August 22, 2014
GO2-14-126

Subject: **COLUMBIA GENERATING STATION, DOCKET NO. 50-397
LICENSE AMENDMENT REQUEST TO REVISE TECHNICAL
SPECIFICATION SURVEILLANCE REQUIREMENT FOR THE ULTIMATE
HEAT SINK**

Evaluation of Proposed Change

Figure 1 – Simplified Diagram

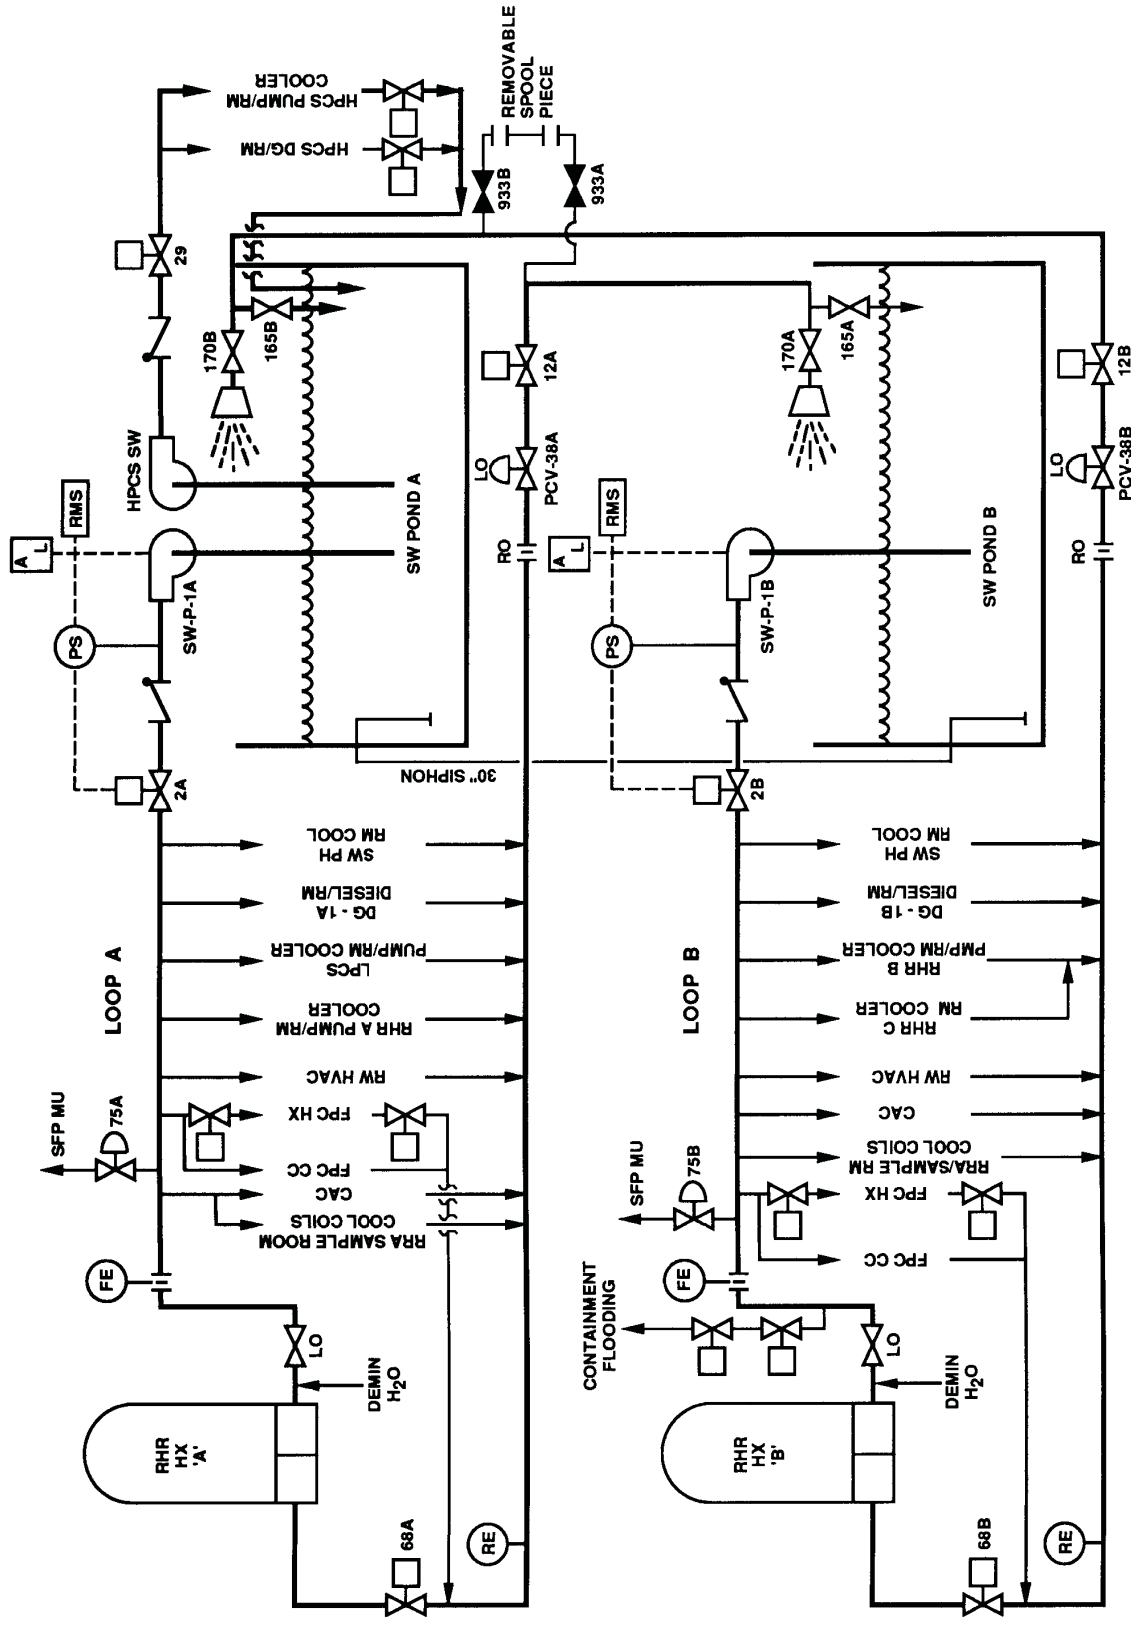
the Division 1 equipment, and discharges through a spray ring into pond B for heat dissipation. Similarly, SW loop B draws water from pond B, cools Division 2 equipment, and discharges through a spray ring into pond A. The water then returns to the initial pond through a 30 inch diameter siphon line. Figure 1 contains a simplified sketch of the UHS and SW system.

Each pond is 250 feet long by 250 feet wide by 15 feet deep. The floor of each pond is located at an elevation of 420 feet mean sea level. The design of the spray ponds includes a non-isolable 30 inch siphon line connecting both spray ponds to automatically transfer water from one pond to the other. A majority of the siphon line is buried; however, sections of the line are not buried and are submerged in the spray ponds after penetrating the spray pond walls. In each spray pond, the submerged siphon line includes a ninety degree elbow which then directs the siphon line downward terminating 18 inches above the floor of the spray ponds. The siphon line between the two ponds is designed to transfer 10,500 gpm without overflowing one of the spray ponds. The siphon line assures that the entire inventory of water in the ponds is available to either loop and that makeup water added to one pond is available to the other. The siphon line allows transfer of colder water from the bottom of the spray pond in which the sprays are operating to the pond from which the operating pump is taking suction. This arrangement provides an effective dispersion of the heat being absorbed by the water inventory. The siphon allows a single train of SW access to the full 30 day supply provided by the two SW ponds.

Figure 2 – Spray Pond Levels

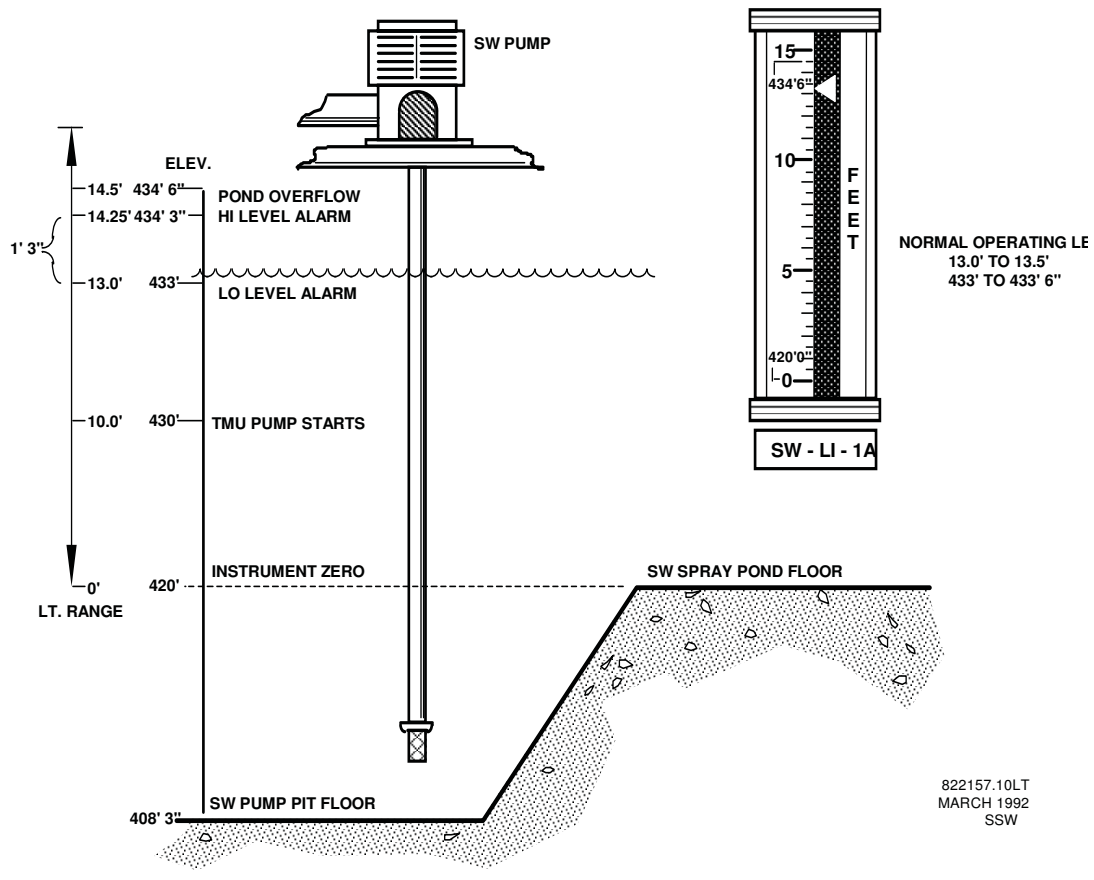
Normal level in the spray ponds is maintained less than 433.5 feet. The high level alarm is at 434.25 feet. The pond overflow is at 434.5 feet. Figure 2 contains a depiction of the spray pond levels.

With one SW pump in operation, the level in the associated pond drops approximately 9-11 inches (0.75-0.92 feet) while the level in the other pond rises by an equivalent amount for a total differential level of 18-22 inches (1.50-1.83 feet). In order to meet the minimum level of 432.75 feet when one SW pump is in operation, the normal level in the ponds would need to be maintained slightly above 433.5 feet. Once the SW pump starts, the level in the pond providing the pump suction will drop to approximately

For instance, with the level in the spray ponds maintained at or slightly below 433.25 feet, the level change due to a single SW pump start is acceptable. That is, the level in the pond with the operating pump will drop to approximately 432.25 feet while the level in the other pond will rise to approximately 434.25 feet. There is a net conservation of water inventory between the two ponds.

Energy Northwest proposes to revise the SR to verify the average water level in the UHS spray ponds is greater than or equal to 432 feet 9 inches (432.75 feet) mean sea level. The spray pond siphon line provides for transfer of water between the two ponds. As long as pond level remains above the siphon (elevation 421.5 feet), water flows between the ponds. The siphon line was tested during startup to confirm that the siphon would not break until the water level reached the bottom of the siphon line in the suction pond. Level changes induced by the operation of a single pump are acceptable as long as the inventory remains within the pond structure. Since the ponds can communicate with each other, the true measure of adequate pond inventory is obtained by averaging the level of the two ponds.
